MFN 06-191
Supplement 10

Subject: Response to Portion of NRC RAI Letter No. 228 Related to ESBWR Design Certification Application – DCD Tier 2 Section 3.8 – Seismic Category I Structures; RAI Number 3.8-41 S06

**Response to Portion of NRC RAI Letter No. 228
Related to ESBWR Design Certification Application**

RAI Number 3.8-41 S06

Figure 3G.1-44. Reinforcing Steel of Top Slab

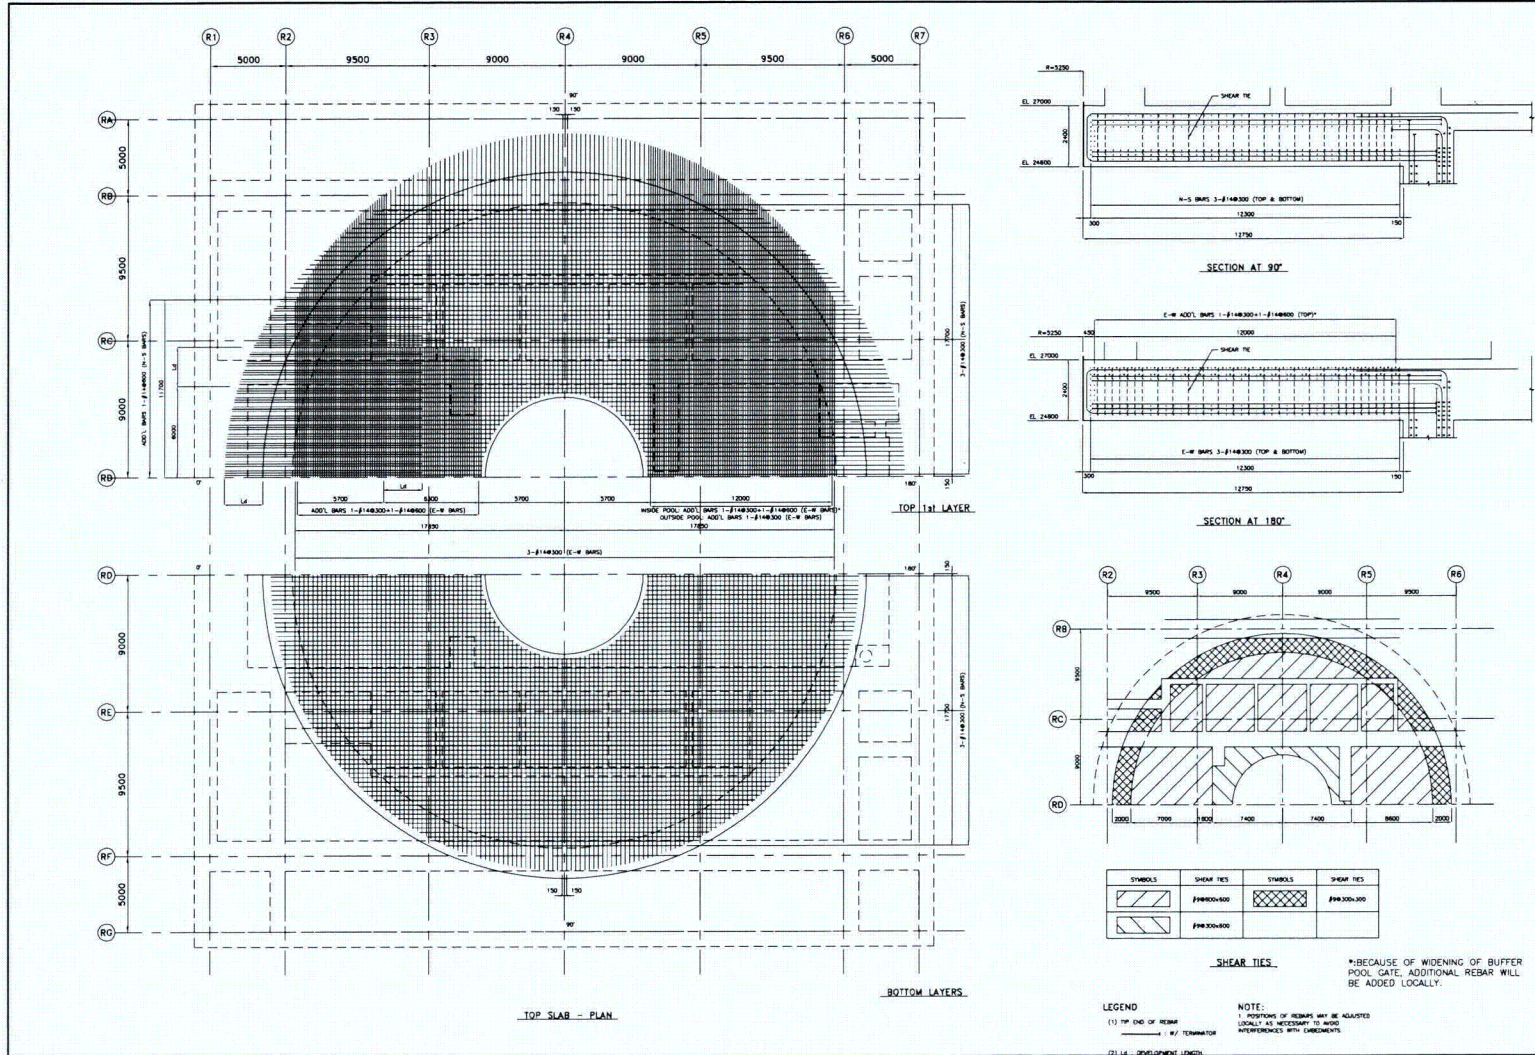
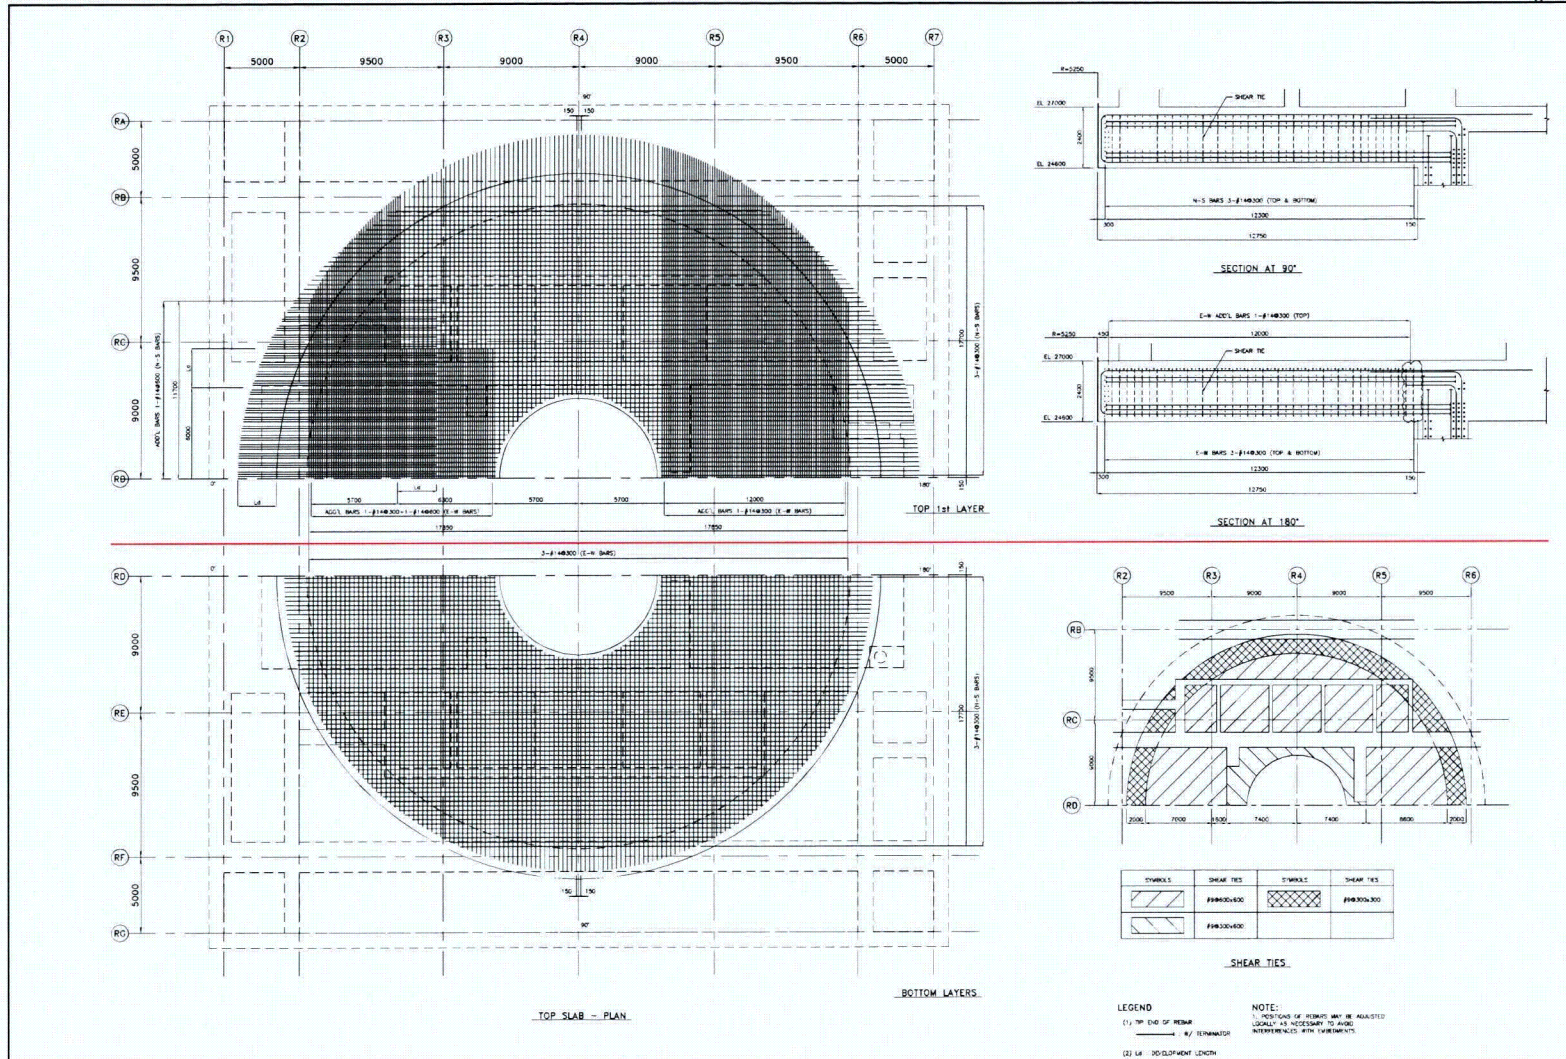
- (a) GEH indicated during the audit that the changes that will be considered in the final design calculation are: (1) consideration of the 100 percent infill concrete, (2) consideration of the revised containment thermal DBA time history (identified in RAI 6.2-180 S01), and (3) widening of the buffer pool gate. GEH also indicated that revisions to DCD Appendix 3G resulting from these changes will not be submitted for review as part of the design certification, but will be performed as part of the detailed design phase. The Design Summary Report and supporting calculations will be prepared to reflect these changes. The staff notes that the introductory paragraph in Appendix 3G of DCD Rev. 5 states that "The final design details, and hence final component stresses may be different from those reported here but they will meet the structural acceptance criteria presented in Section 3.8 in accordance with Tier 1 ITAACs in Tables 2.16.5-2, 2.16.6-2, and 2.16.7-2." Since the three changes listed above may affect the design results, and GEH does not plan to incorporate the changes in the DCD, GEH is requested to (1) identify in the DCD the reported results that did not consider the three changes listed above, (2) perform a quantitative evaluation to demonstrate that structural design will not be affected due to these changes, and (3) include a note in the DCD to state that a quantitative evaluation was performed to conclude that final design will not be affected by the changes.*

As for the thermal load, the element force distributions of all components are almost the same for both models. As for the pressure load, however, the element forces of the 'My' bending moment component around the drywell head opening increase about 20 percent from the DCD Revision 5 element forces as shown in Figure 3.8-41(64). The existing stress margins, which are the ratio of the calculated stress to the allowable stress, in accordance with DCD Tier 2 Tables 3G.1-10 and 3G.1-11 are not sufficient to accommodate the increased accident pressure stress. Therefore, additional bars (1-#14@600) will be added locally and DCD Tier 2 Figure 3G.1-44 will be revised accordingly.
